ZTE CORPORATION**Product Change Description**

[Smart Tab 7]
[ZTE Corporation]

Front plastic cover change:

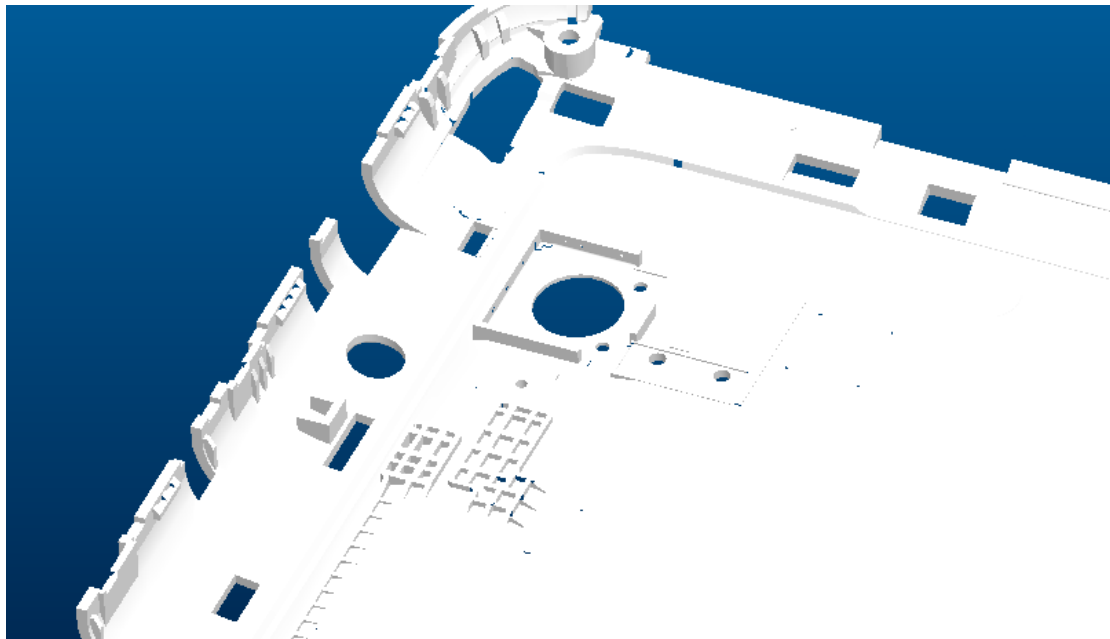
Before:

After:

Reason for changes: enhance strength of front cover.

Back plastic cover change:

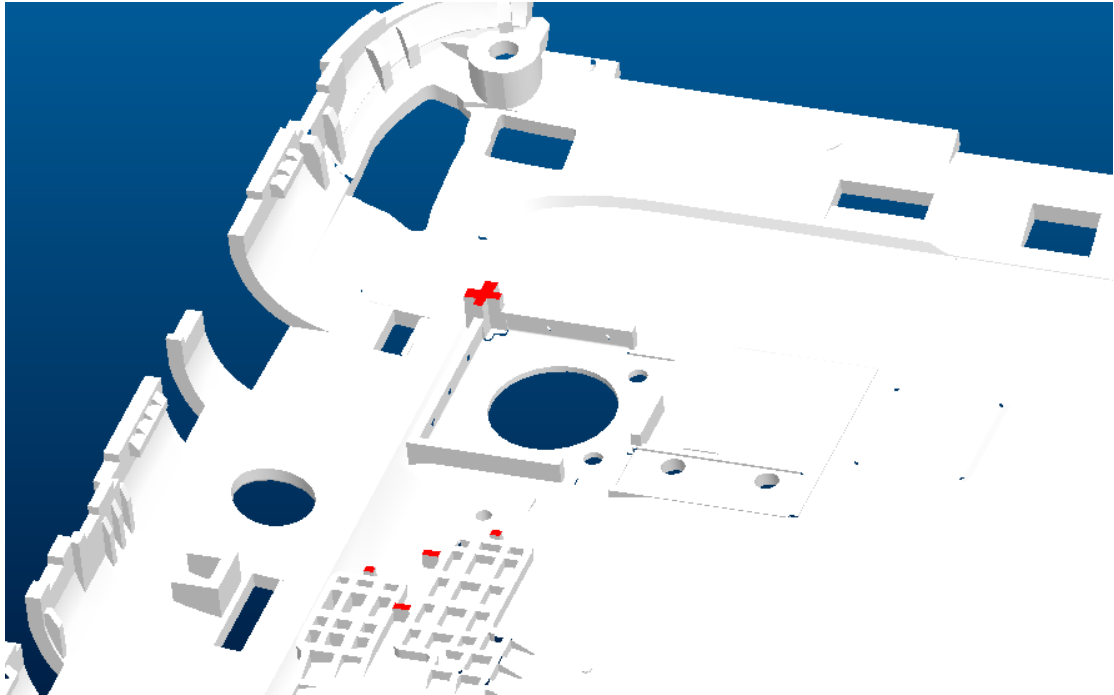
Before:

After:

Reason for changes: First, improve location accuracy of FPC.
Second, support main pcb.
